JC ENGINEERING, Inc.
Civil & Environmental Engineering

January 6, 2022

RE: Consulting Engineer Review Comments for The Definitive Subdivision Plan for Tobia Way, Wareham, MA

Pond 1P: Detention Basin

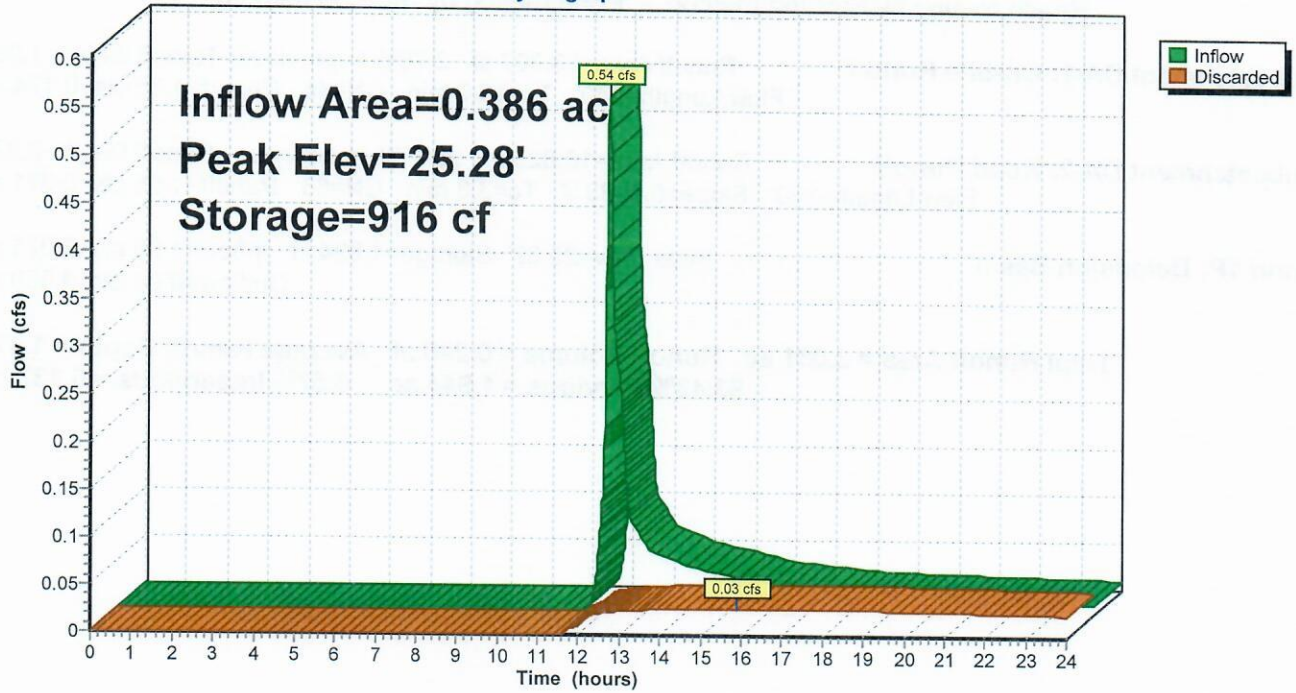
1. The stormwater requirements appear to have been met with the exception of confirming that abutting properties or ways will not be adversely impacted by the development or a 100-year storm event. See Section V, Design Standards, B,1 of the Rules and Regulations. Additional information is suggested.

The size of the retention basin has been slightly enlarged to ensure runoff from a 100-year storm event will not flow over the perimeter of the retention basin and therefore will not adversely impact any abutting properties of ways. The stormwater analysis has been updated to show the peak elevation of stormwater during a 100-year storm event.
